NORTH SALT LAKE PLANNING COMMISSION NOTICE & AGENDA July 9, 2019 6:30 p.m.

TO: Planning Commission
FROM: Sherrie Llewelyn, Community Development Director
DATE: July 9, 2019
SUBJECT: Consideration of a Concept Plan for a PUD Subdivision, Orchard Drive Townhomes, located at 142 South Orchard Drive

TO: Planning Commission
FROM: Sherrie Llewelyn, Community Development Director
DATE: July 9, 2019
SUBJECT: Concept Plan for a three lot subdivision, Lake View Subdivision and conditional use permit for a flag lot at 824 Eaglepointe Drive

SITE PLAN

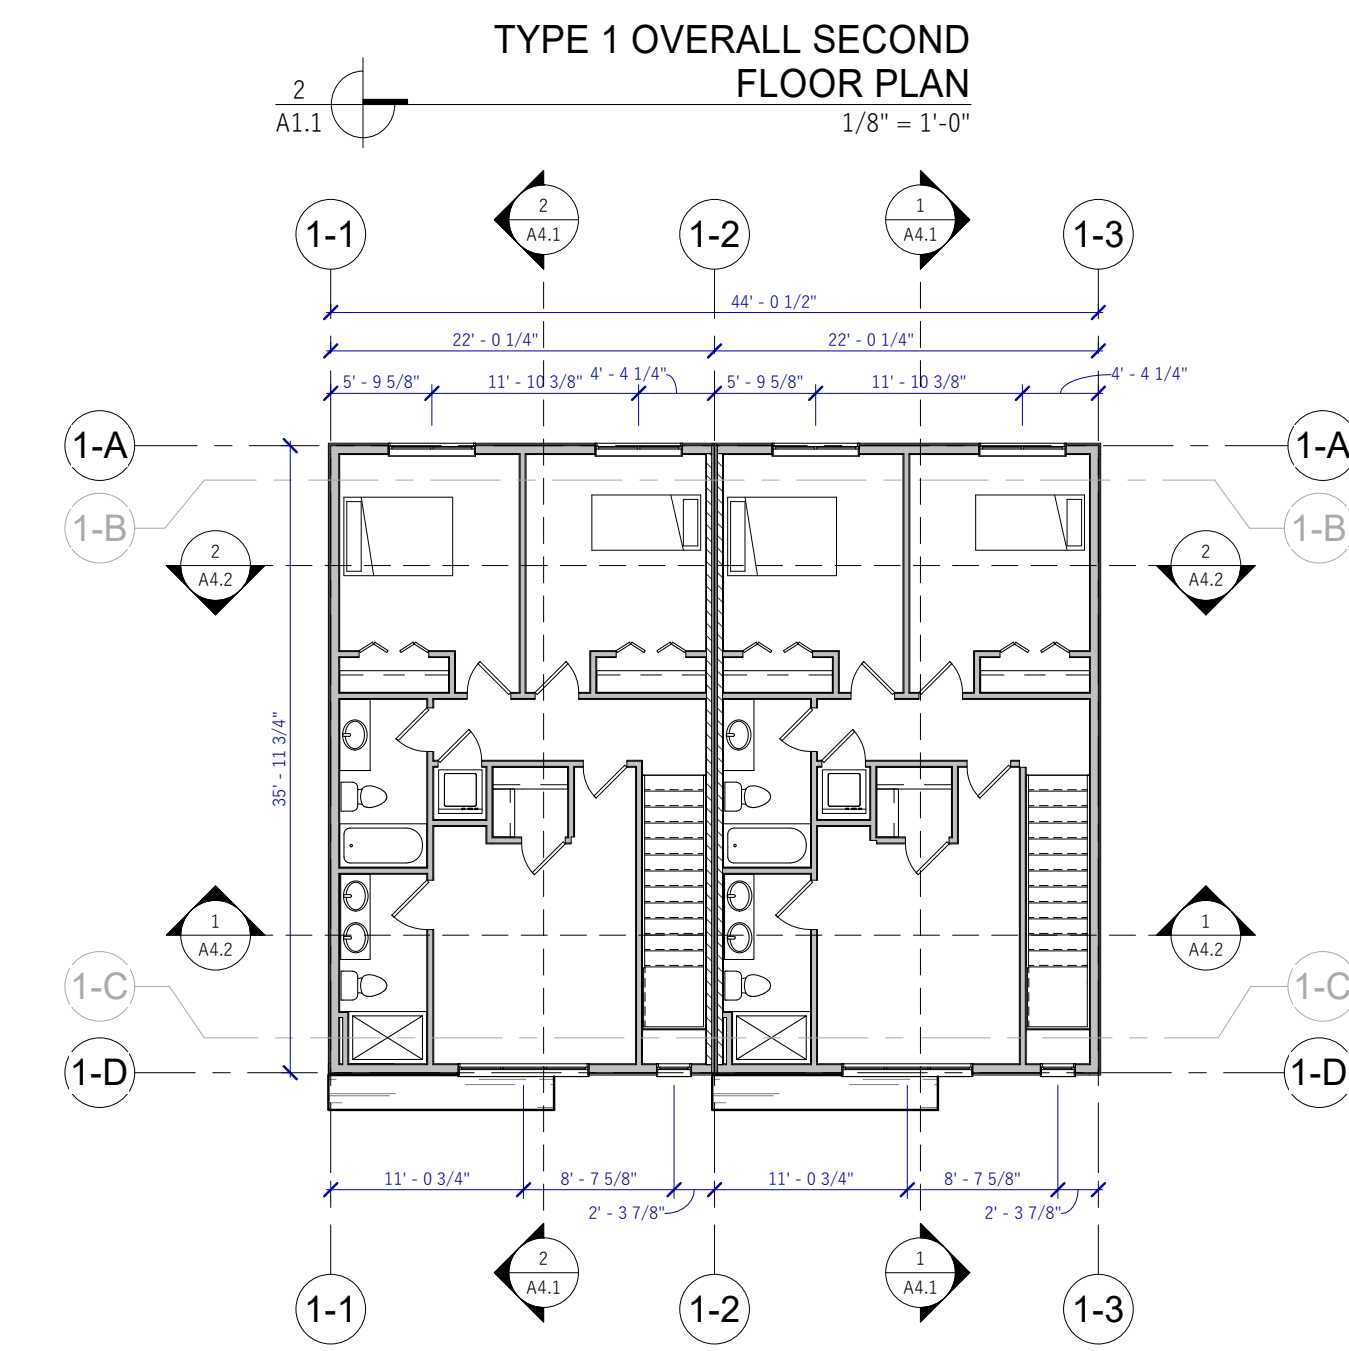
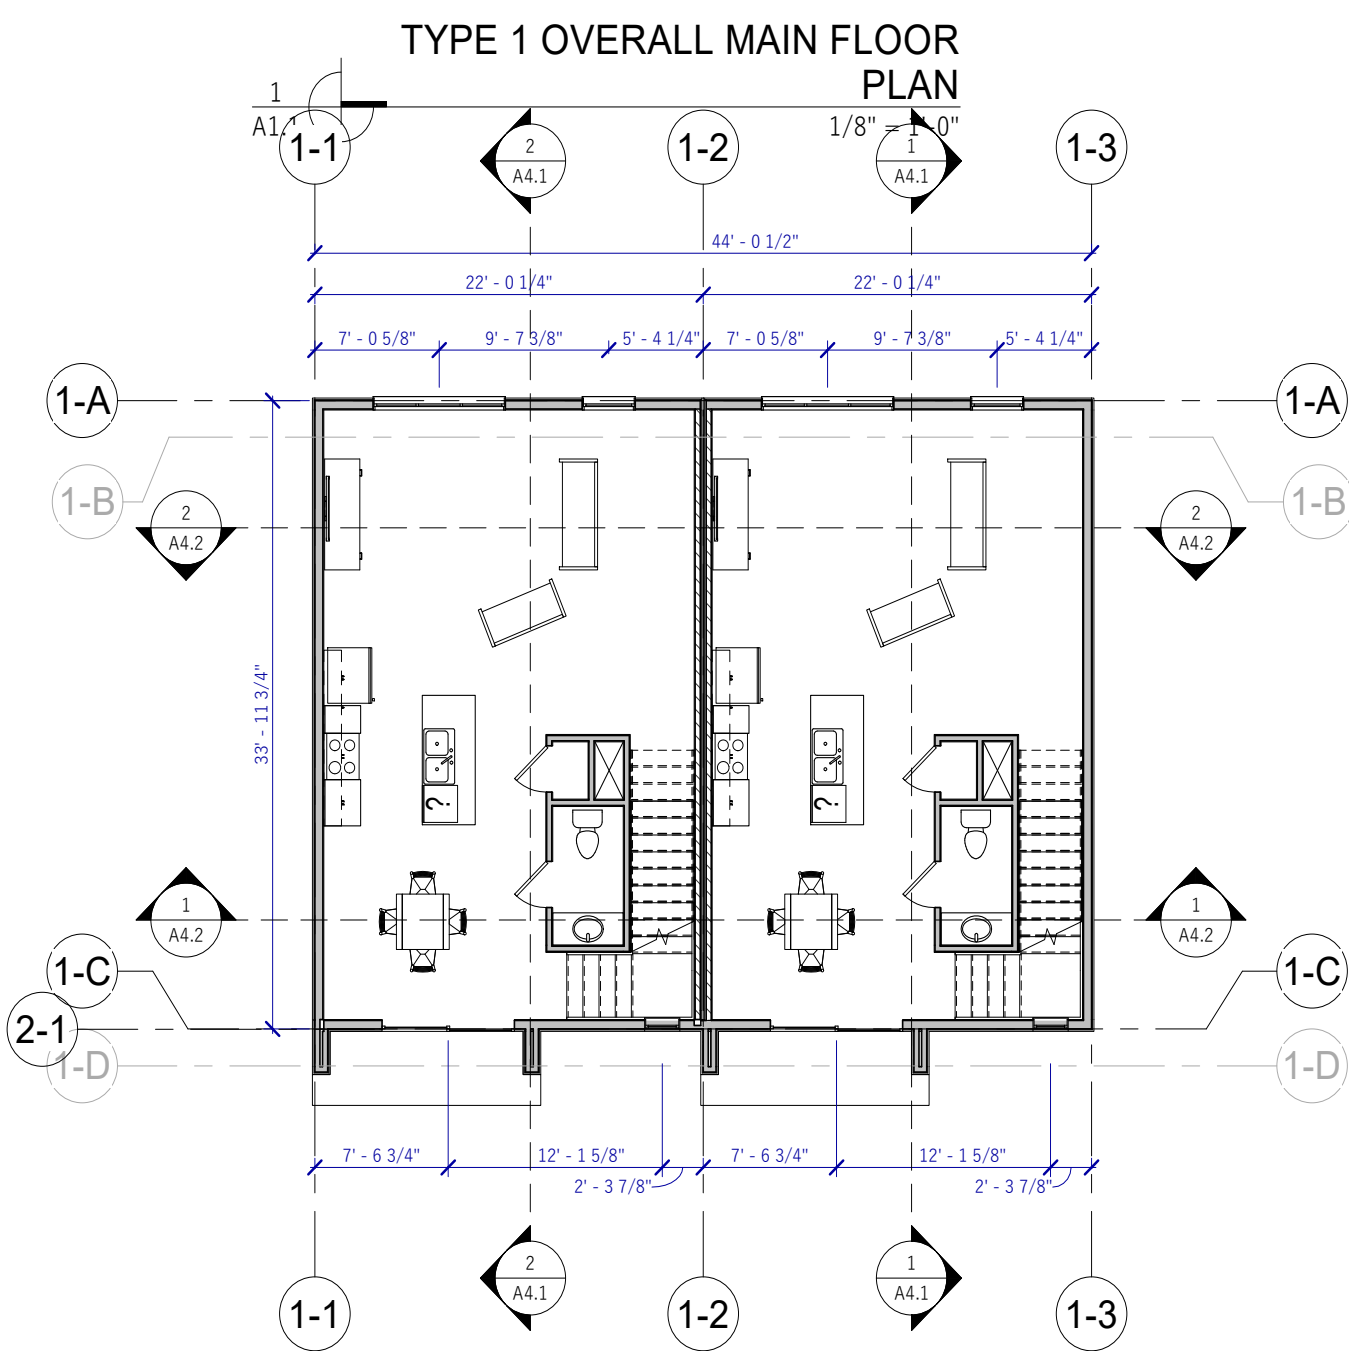
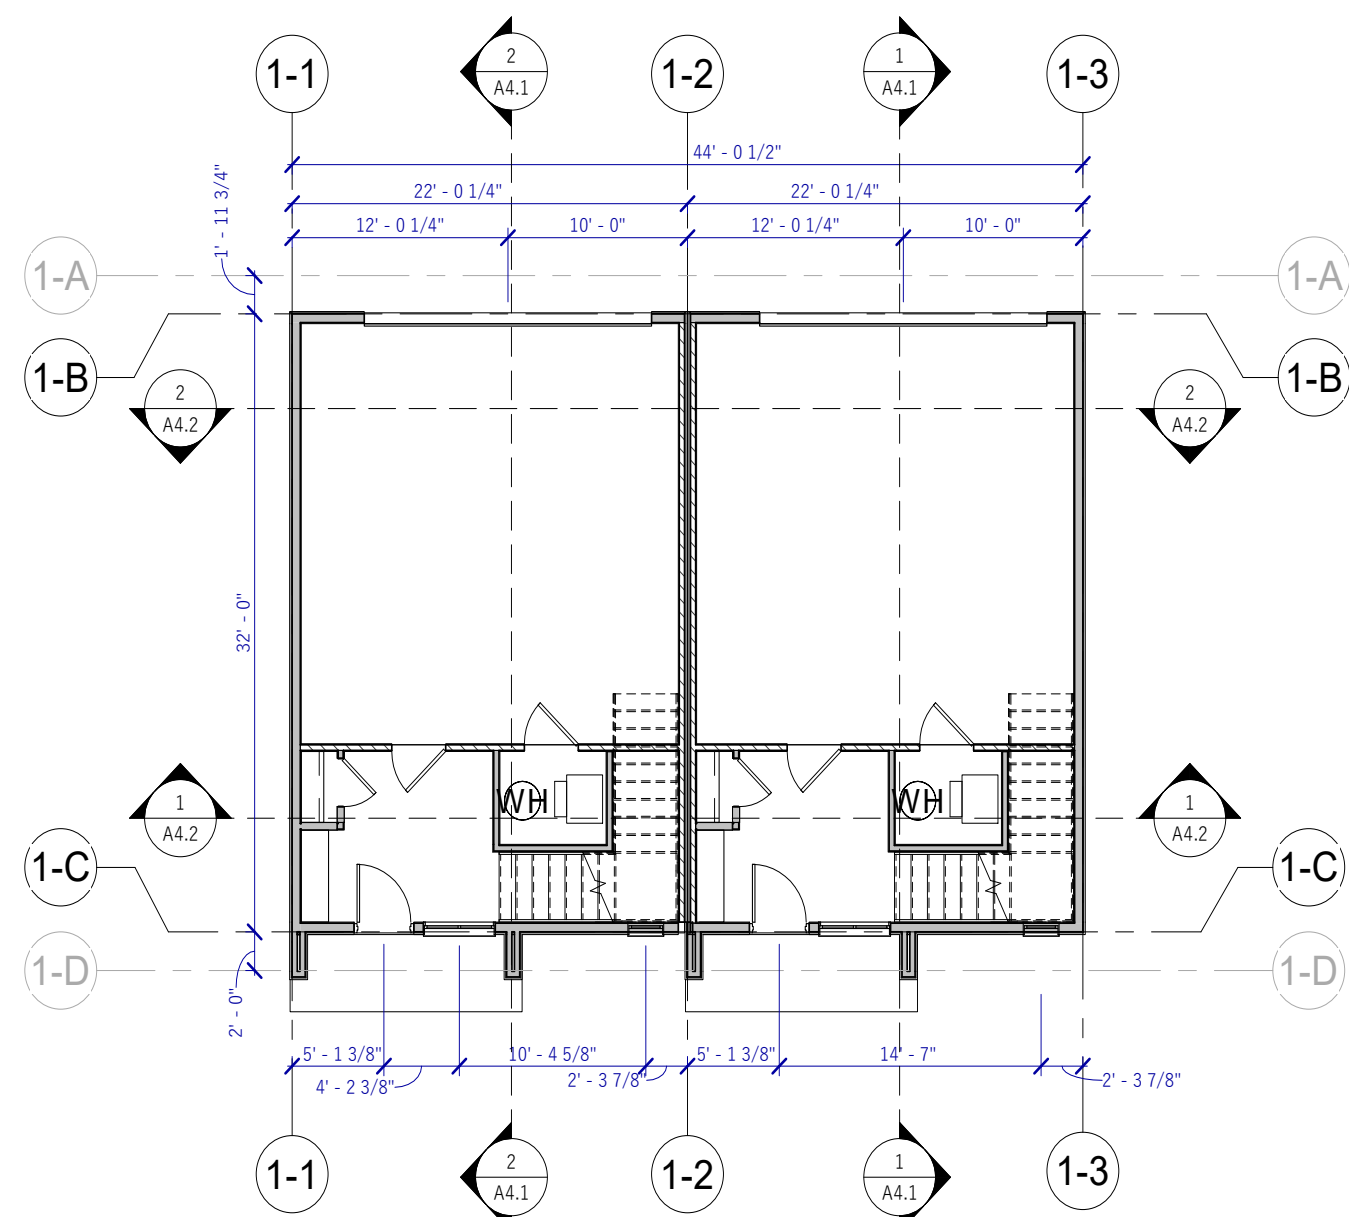
2. **Layout:** The proposed layout places 26 townhomes on the 1.3 acre site. The two single family homes on the site will be razed. The lots are to be platted as “for sale” townhomes in a PUD with the shared private road and common area. There are 7 units that face Orchard Drive, with rear entry garages. All units will have rear entry garages. There is a 20 foot drop in elevation from east to west. The main private street on the lot will have a slope of 10% for the longest portion of its run.

3. **Setbacks:** Standard setbacks under the RM-20 zone are front 25’, side 8’ (total of 20’) and rear 20’. Under a PUD Subdivision, the Planning Commission determines the required setbacks, which may be varied from the standard. The proposed layout has a front setback (Orchard Drive) of 15 feet from the new property line after the dedication of 4.5’ to complete the required 66’ right of way width. A 5’ sidewalk is proposed. The setback distance from the building to the curb is 22.5’. Proposed side yard setbacks are 6’. The layout meets the minimum rear setback.

4. **Height and Stories:** The maximum height for the RM-20 Zone is 35 feet and with no maximum number of stories. Under a PUD Subdivision, the Planning Commission determines the maximum height, which may be varied from the standard. The proposed townhomes facing Orchard Drive will be 2 stories high with a pitched roof for a total height of 29’. The downhill side of the units will be 3 stories with a rear entry garage on the basement level. The 2 most western units will also be this type with 2 stories at the front door and 3 stories on the downhill garage side. The middle 3 buildings will all be three stories with a maximum height of 39’.

5. **Lot Size:** The minimum lot size for the zone has been met.
6. **Coverage:** The townhomes constitute approximate 18,185 sq. ft. of the 1.3 acre townhome site, which is 32% coverage. The maximum coverage by buildings is 50%.

7. **Landscaping:** The proposed landscaping on the townhome site is approximately 15,194 sq. ft. or approximately 27% of the site. The minimum requirement is 10% landscaping.

8. **Parking:** Required parking under the code is 2.25 parking spaces for each residential unit, of which 1 stall per unit must be covered. Each of the proposed townhomes have 2 car wide garages, providing 52 parking spaces. Additionally 6.5 spaces are required for guest parking and 11 spaces are proposed. Units 10-13 have driveways capable of parking 2 cars each for another 8 parking spaces, and unit 9 has a driveway that 1 additional car could be parked on. The townhome site exceeds the minimum requirement. The proximity of the guest parking to the individual units cannot be proportionally dispersed throughout the units due to the topography of the site. The upper units 1-6 and 19-26 have 4 guest parking spaces within the required 200 feet walking distance. The lower units have 7 guest parking spaces and the 9 driveway spaces.

1. The Planning Commission approves that the minimum standards shall be varied per the PUD ordinance provisions for property setbacks as follows: Front-15', Rear-20', and Side-6'; and
2. The Planning Commission approves that the minimum standards shall be varied per the PUD ordinance provisions for maximum height of 39'.

Lake View Subdivision

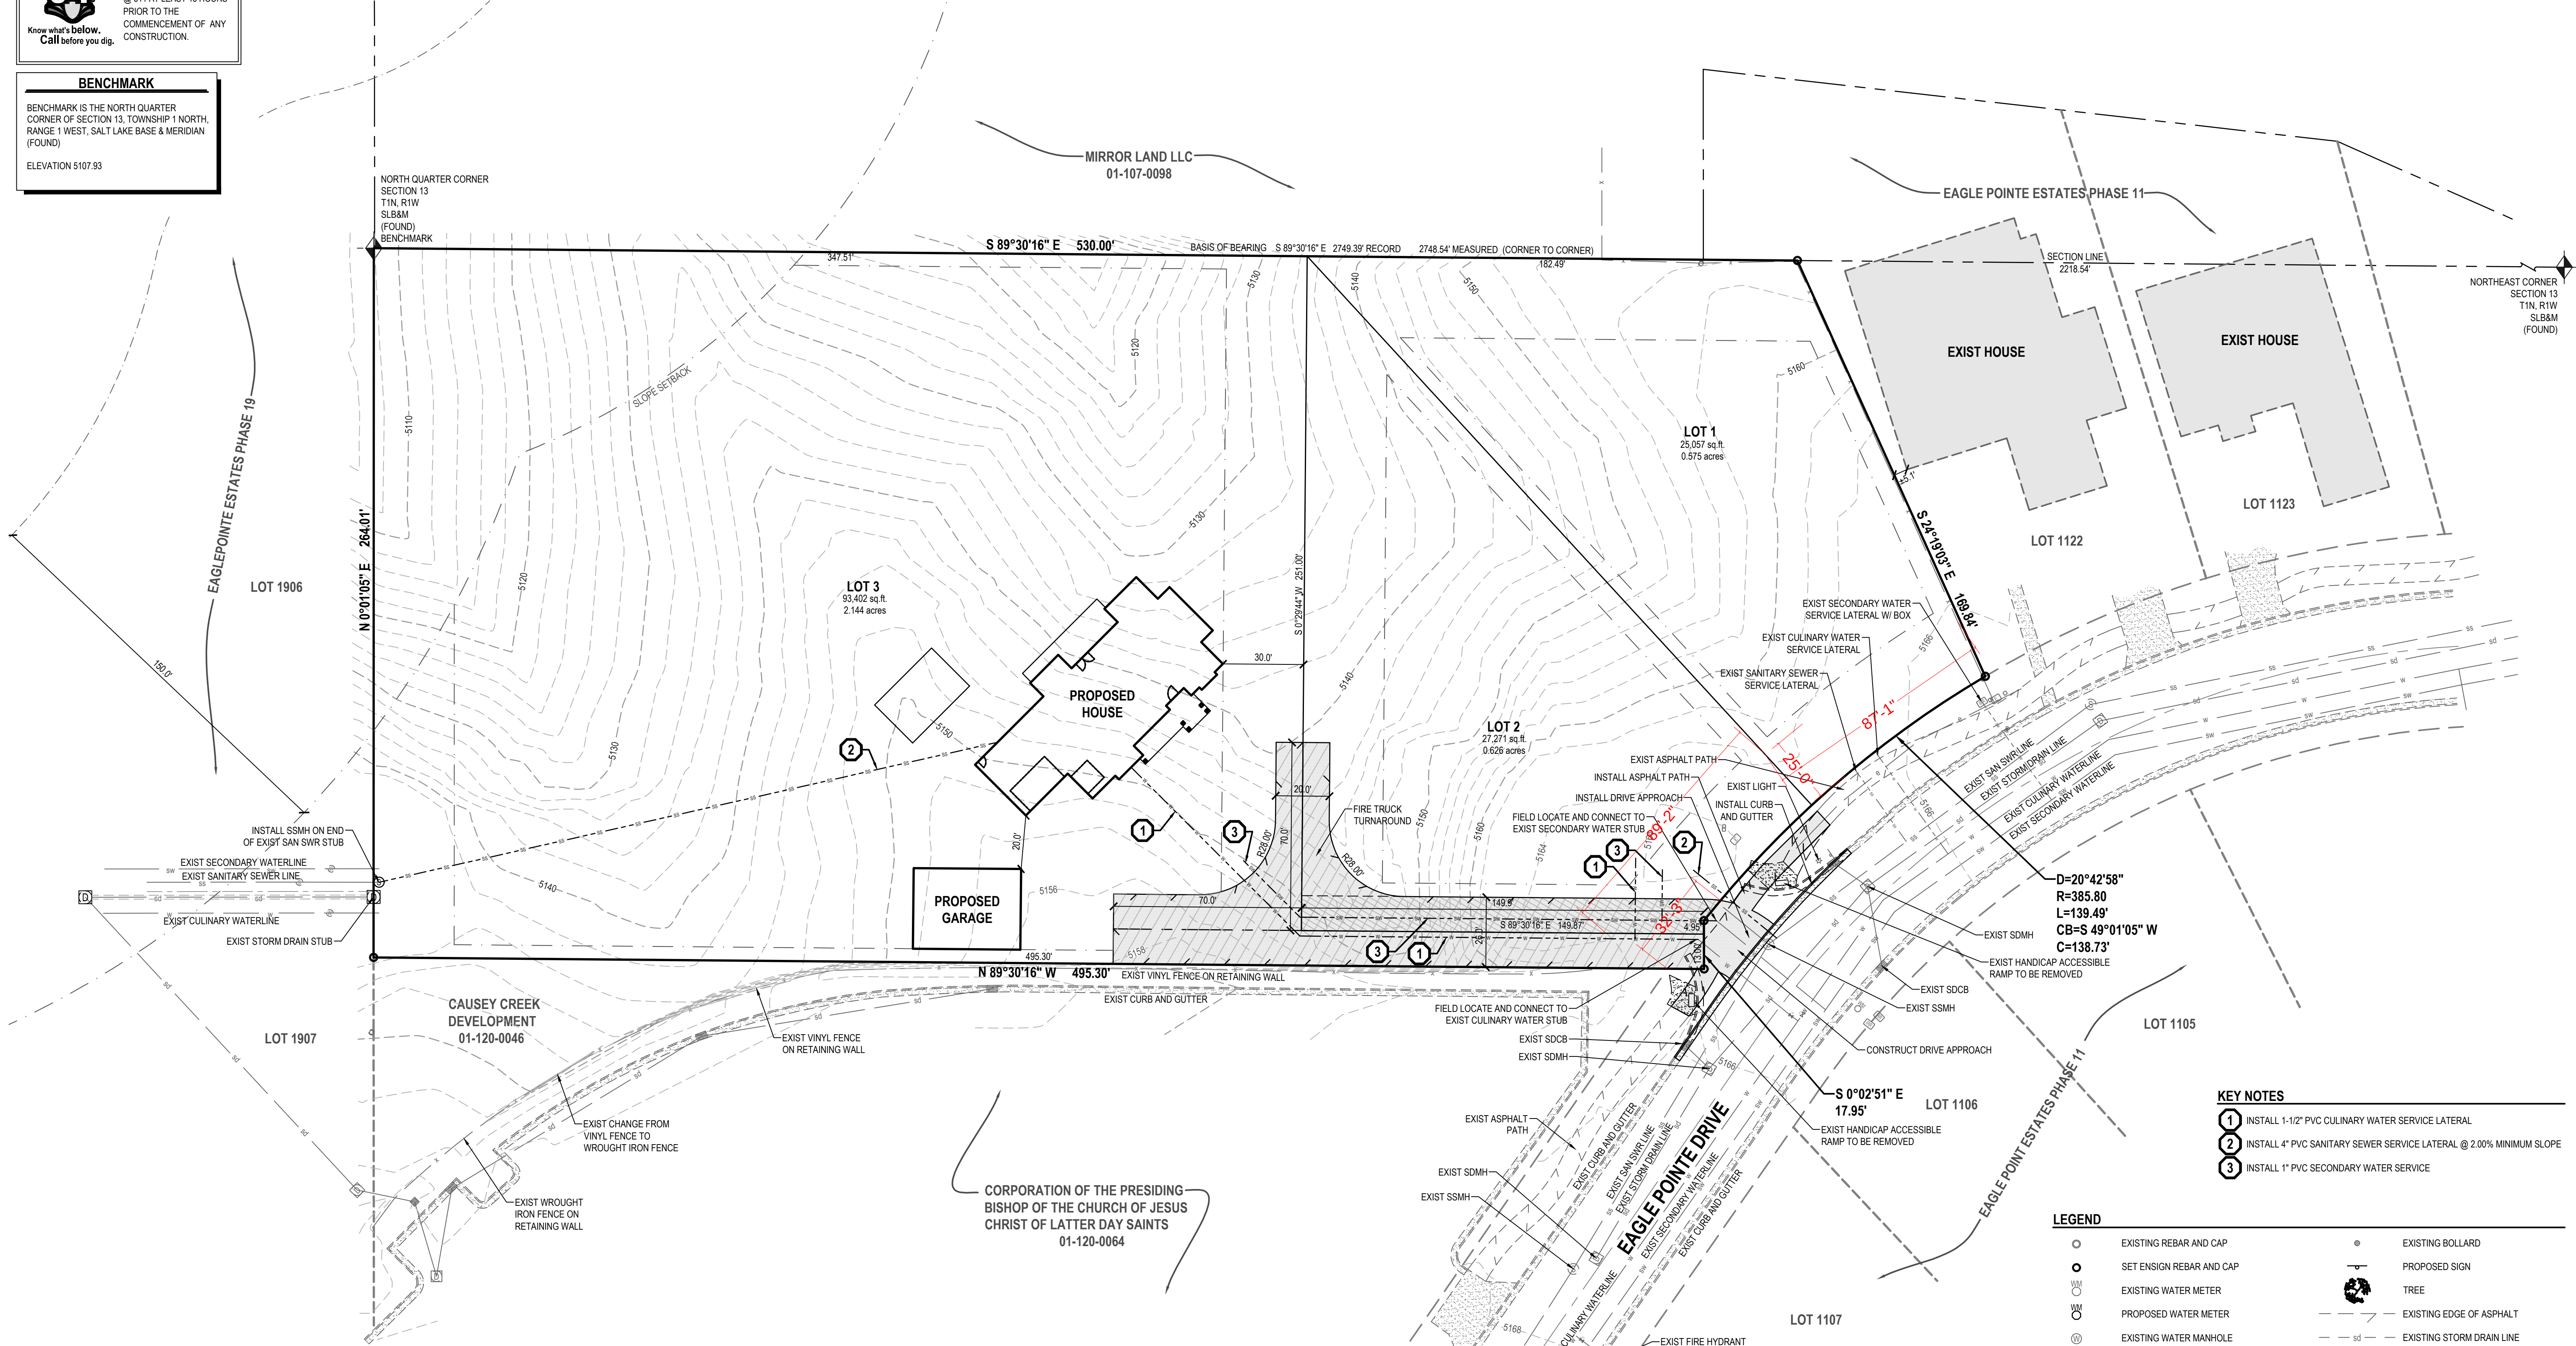
These properties are located at 824 Eaglepointe Drive and contain approximately 3.34 acres. The property is zoned Residential (R1-10) and the developer proposes to create 3 new lots. Lots 1 & 2 have direct frontage along Eaglepointe drive and meet the minimum width requirement of 80'. The flag lot staff as currently shown is less than the required 30 feet of width, but can be revised prior to preliminary plat to meet the requirement.

All lots meet the minimum lot size of 10,000 sq. ft.; lot 1 is 0.575 acres, lot 2 is 0.626 acres, and lot 3 is 2.144 acres. Each lot must demonstrate a minimum 5,000 sq. ft. of building envelope. The City Engineer has reviewed the lots and believes they all exceed this requirement but will be verified with the geotechnical analysis that will occur prior to preliminary plan submittal.

1. Approval of a geotechnical study required by Title 10, Chapter 12 of the Land Use Management Code, prior to submission of a preliminary plan application;
2. The staff portion of lot 3 must be increased to the minimum width requirement of 30'; and
3. Submission of slope analysis demonstrating building envelopes for each lot of at least 5,000 sq. ft. with a slope under 30%.
